20 – 21 King's Mews
London, WC1N 2JB

Basement Impact Assessment
Audit

For
London Borough of Camden

Project Number: 12336-54
Revision: F1

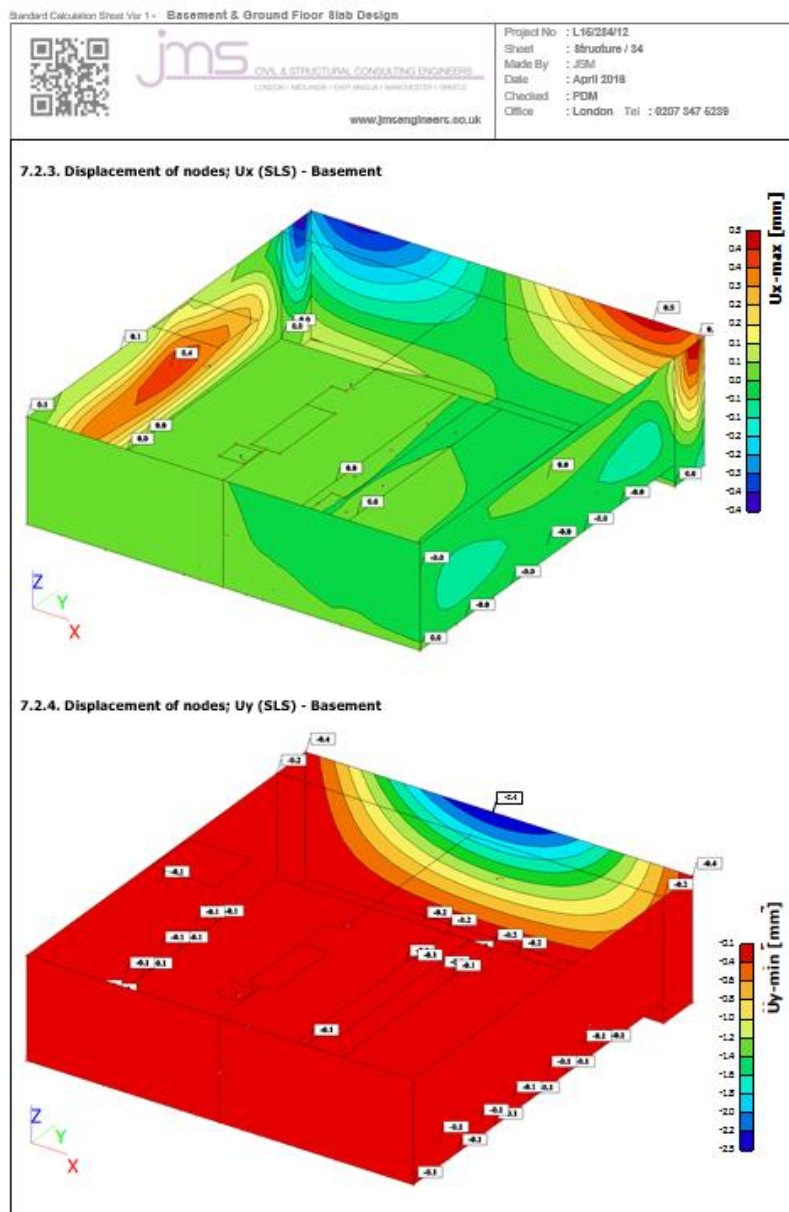
The proposed development has been designed and detailed in a way to be independent of the existing structures, walls and foundations by creating a reinforced concrete ‘box’ within the footprint of the building and supported on a piled structure.

- The side walls, in the permanent state, are propped at basement and ground floor level reducing lateral movement to virtually zero.
- The rear wall abuts an existing basement with subsequent retention of approximately 1.8m. Lateral movement is predicted to less than 2mm
- The front wall, in the permanent state, is also propped at basement and ground floor level reducing lateral movement to virtually zero.
- Subsequently, the impact on the highway and any services is zero

The estimated movements (see below) are considered to represent a worst case scenario, particularly as the movements resulting from basement excavation will be minimised due to control of the propping in the temporary works and a regime of monitoring

7.2.4. Displacement of nodes; Uy (SLS) - Basement

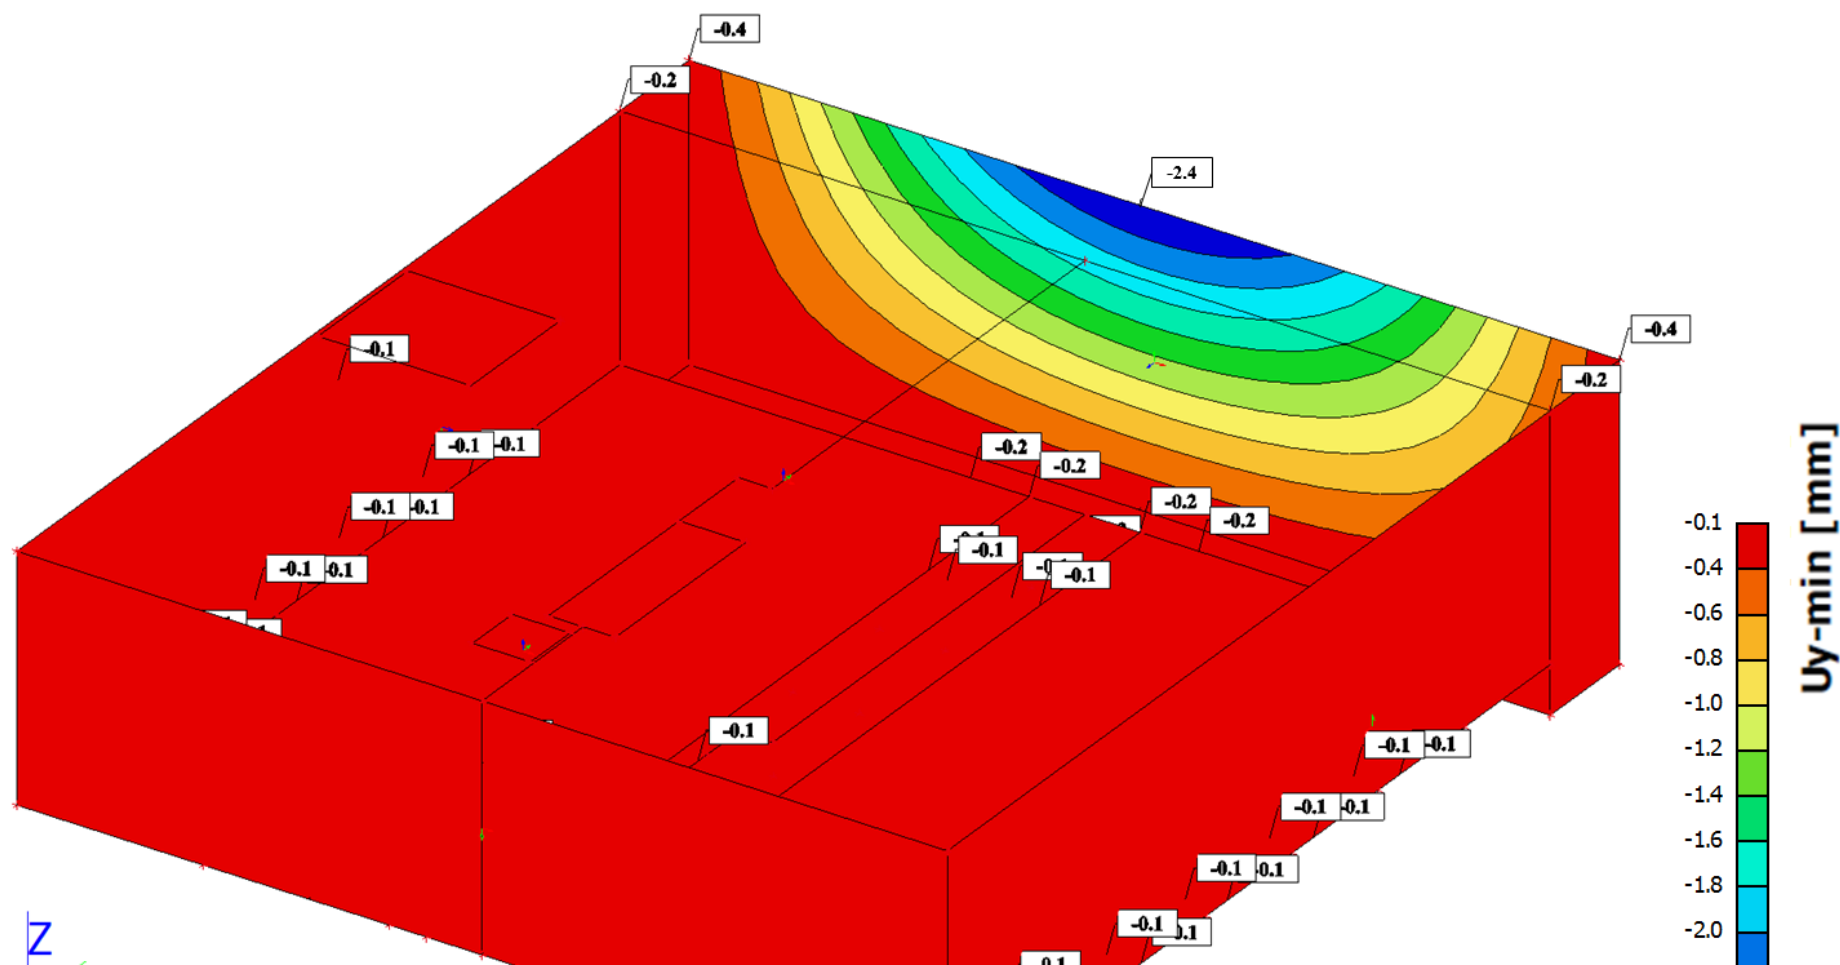
8. I have replicated in Appendix A the predicted lateral movements of the retaining walls which I believe were not clear on the previous submission. As you will see, due to the presence of the existing neighbouring basements, the stiffness of the proposed walls and propping action of the ground floor slab, the predicted movements are generally less than 1mm. Please note, the 2.4mm deflection to the wall abutting 53/55 Grays Inn is at the top. The Grays Inn Road properties, as confirmed above, have basements to a depth of approximately 2.2m below Ground level where the deflection is less than 1mm.
